Re: Collin County Medical & Mental Health

Subject: CO #0100 – Alternate 3 AHU 8 Duct (RFI #235)

Proposed Change Request
CO - 100

235 - Air Handling Unit Discrepancy Between Alternates

LEVEL 2 - MALE
SUB-ACUTE B FLOOR
PLAN - DUCTWORK

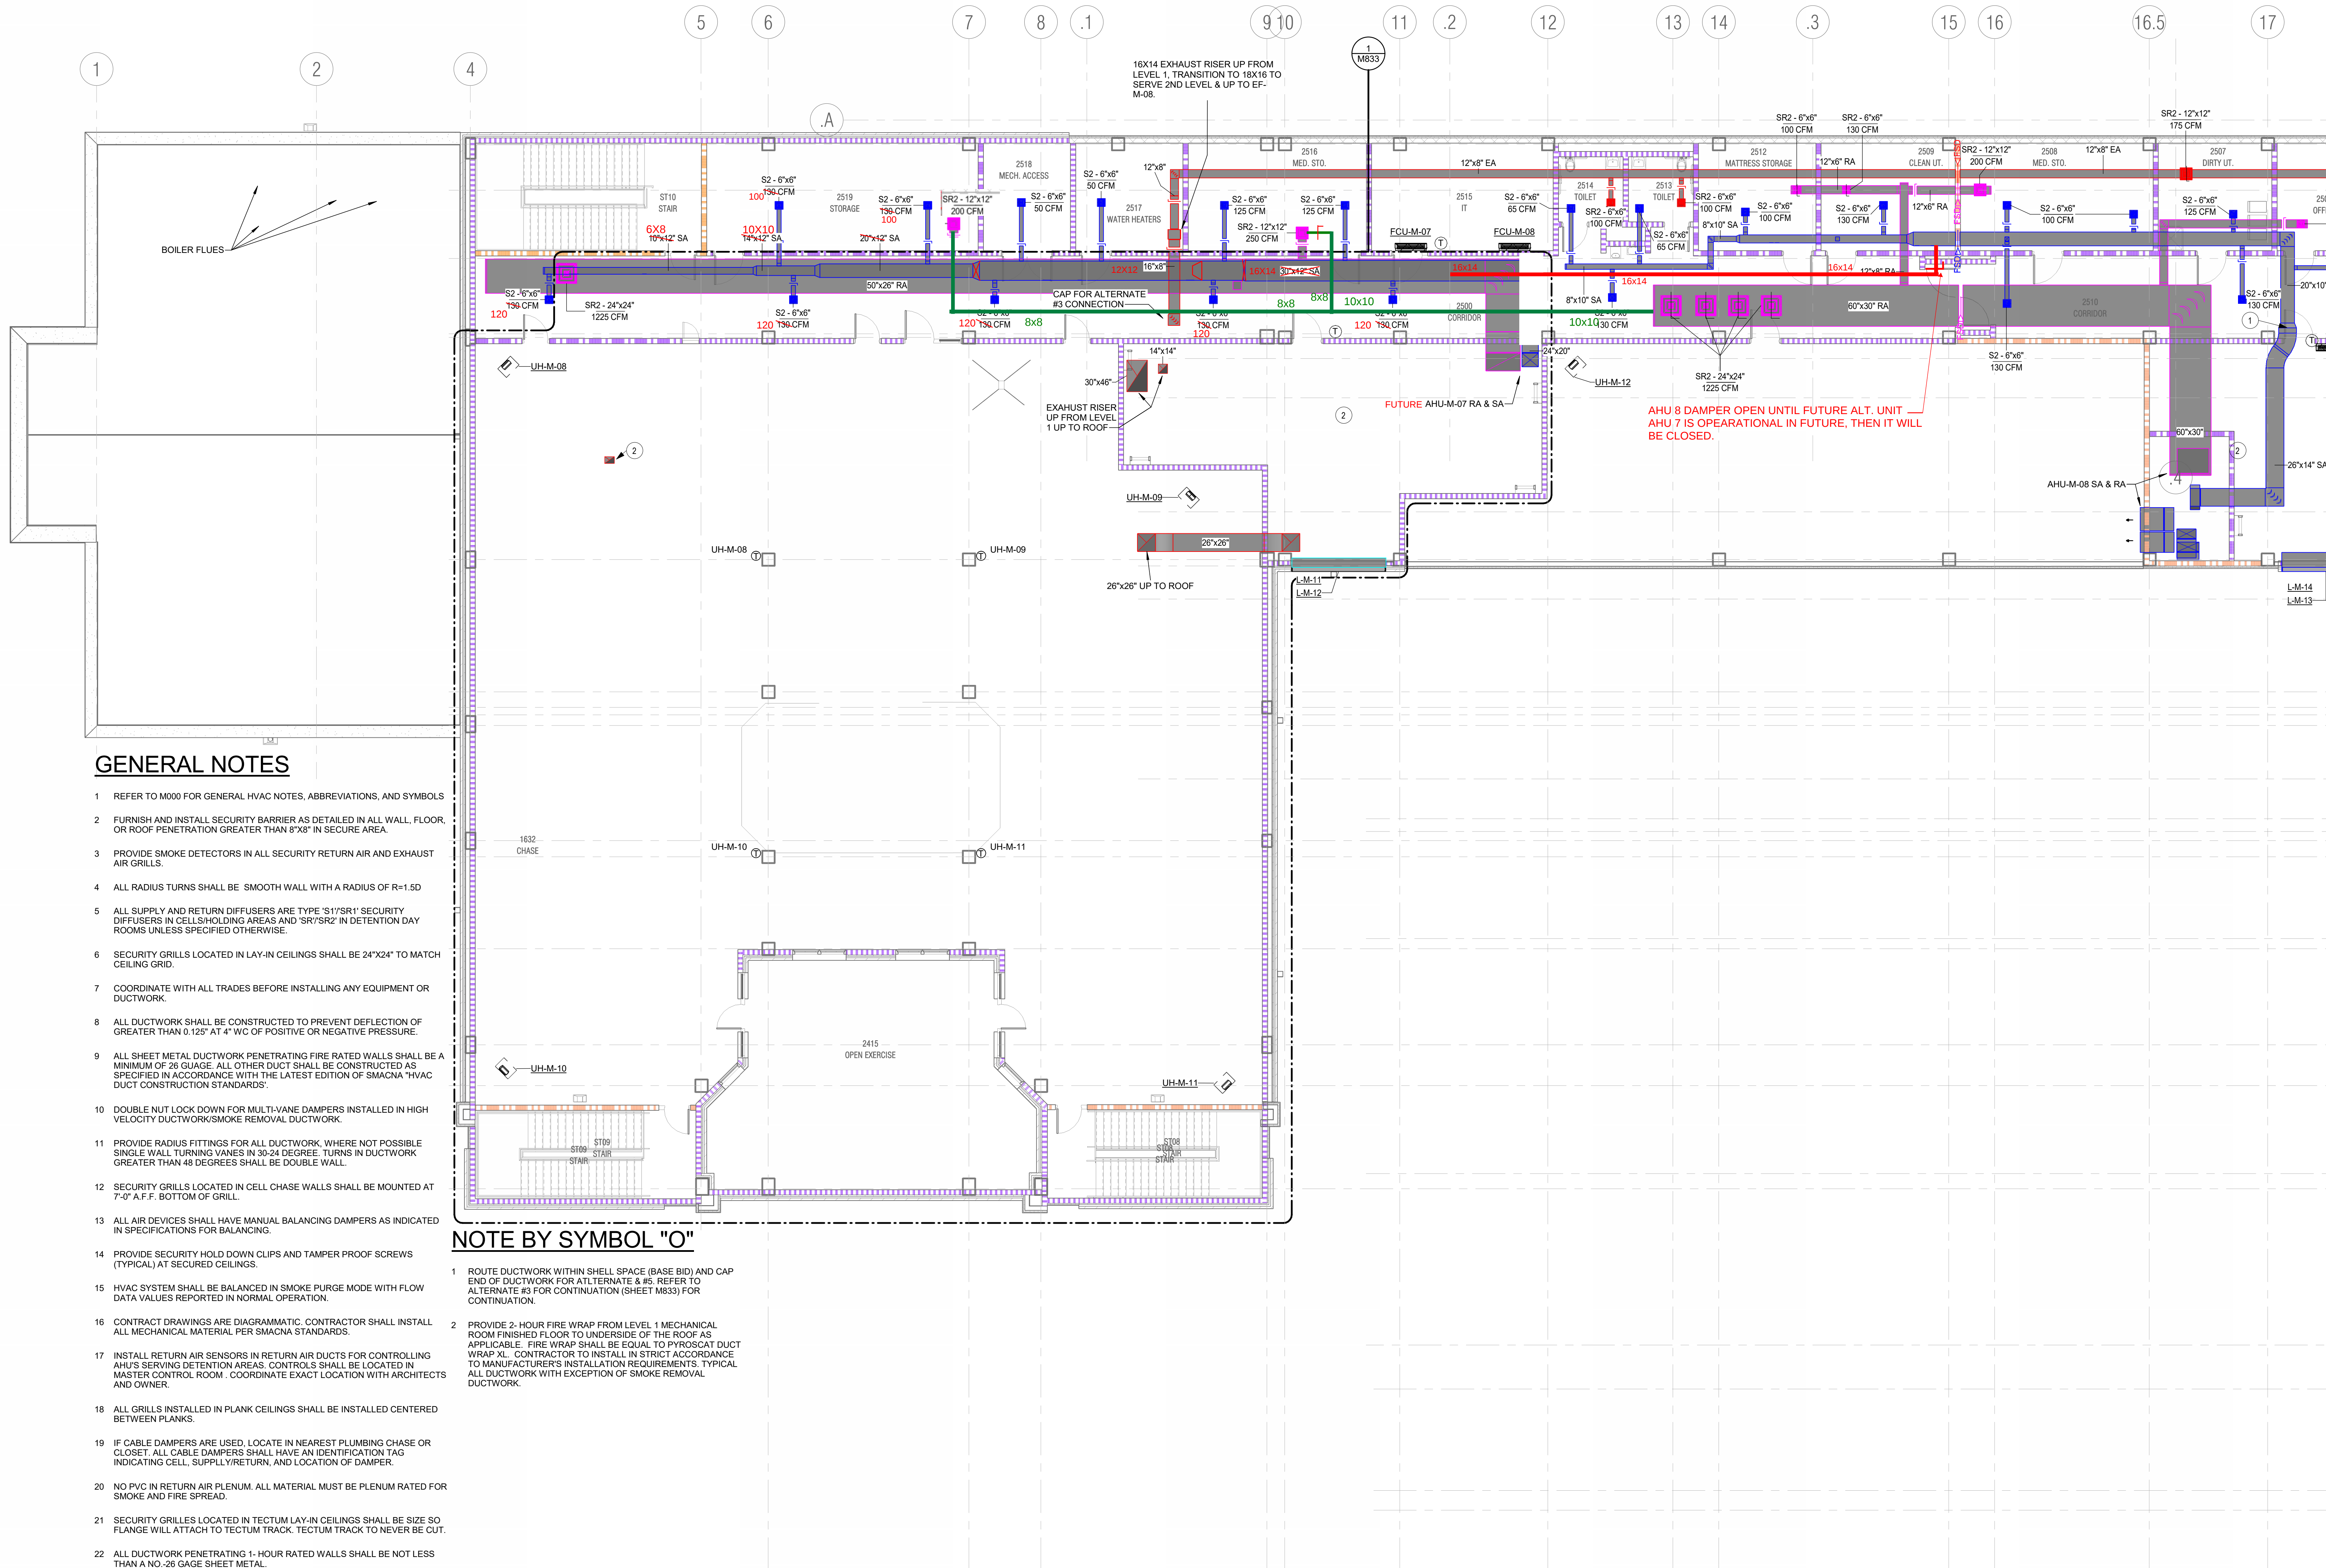
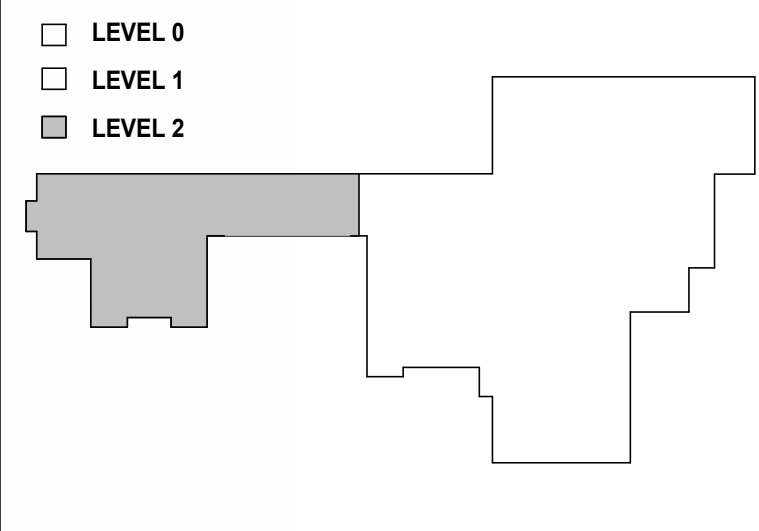
According to the attached sheet M830 air handlers 07,09 and DOAS-2 are all included in alternate #3, and have not been picked up in the current scope of the project. However, sheet M223 of ASI#1 added duct distribution and trim out for conditioned storage and mechanical spaces at 1600 level 2. This space is indicated to be supplied for AHU-07, which is not apart of the base bid. Coordination has taken place with the vendor supplying the AHU and they have confirmed that it is possible to increase the capacity of AHU-8 to pick up the extra 1400cfm required for these spaces with minor modifications being made to the unit. The duct sizing for AHU - 08 will need to be confirmed along with the supply and return ducts. A secondary option would be to provide a DX refrigerant split system unit to serve the 1600 level 2 space. Please provide the appropriate course of action.

Refer to mark ups on attached drawing

Lochridge Priest 2960 Wesley Way Ft. Worth, TX 76118 Phone: (254) 772-0670 Fax: (254) 772-0484		Project: Collin County Mental Health Expansion 4300 Community Ave. McKinney, TX 75071	
To:	Sedalco Construction Services 4100 Fossil Creek Blvd. Ft. Worth, TX 76137	MDE Project Number:	221424
Attention:	Will Burgess	Job Number:	FT240021
Phone:	(817) 271-6059	Date Sent:	5/12/2025
Fax:	NA	LP RFI Number:	38
		GC RFI Number:	
☒ Possible Cost Impact ☐ Cost Impact ☐ Schedule Impact			
Subject: AHU Discrepancy			
Reference Dwg: M201R/M223/M005/M830		Specification:	
Information Requested:			
Per sheet M830, Air Handlers AHU-07 & 09 and Outside Air Unit DOAS-2 are to be included with Alternate #3, and are not currently in the scope of the project. However, ASI #1 (M223) added duct distribution and trimout for conditioned storage and mechanical spaces at 1600 level 2, which is supplied from AHU-07. LPI has coordinated with the AHU supplier and it is possible to increase the capacity of AHU-08 to pick up the extra 1400cfm for these spaces (if we act quickly). With that, the current duct sizing of AHU-08 would need to be confirmed by EOR and the SA/RA duct connections to base scope AHU-08 ductwork detailed at level 2 1600. The increased capacity to AHU-08 and duct modifications will be a cost impact.

DESCRIPTION: RFI 235 Alternate 3 AHU Ducting
Finished spaces in the second floor of the 1600 wing are shown to be fed from AHUs & DOAS units that are a part of Alternate 3 which were not included in the Contract. RFI 235 gives direction to add duct work to feed these spaces and provide a damper that will be closed once the future work is put in place.

We take no exception to the response provided by MDE. Please provide pricing for this work prior to proceeding.
